FIELD SERVICE CAMPAIGN – 20107

Air Conditioning (A/C) Refrigerant Charge

International® HX® Series built 10 June 2019 thru 27 August 2019

Figure 1. Label

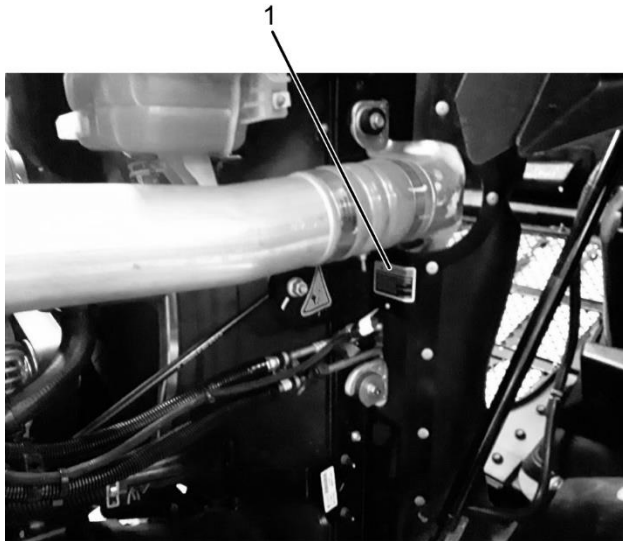
The A/C refrigerant system may be overcharged resulting in excessive cooling fan operation and reduced fuel economy. All other vehicles built during this period have either been repaired prior to shipment or determined to not require this repair.

1. Label location
7. Locate existing label on upper passenger-side of cooling package (Figure 1, Item, 1).
8. Clean existing label and surrounding area of any dirt / grease.
9. Peel backing off new label.
10. Apply new label directly over existing label. Smooth out ripples.
11. Charge refrigerant system to 2.5 lb as specified on new label installed in Step 10. Refer to appropriate technician manual for detailed instructions.
12. Close and latch hood.
13. Remove wheel chocks.
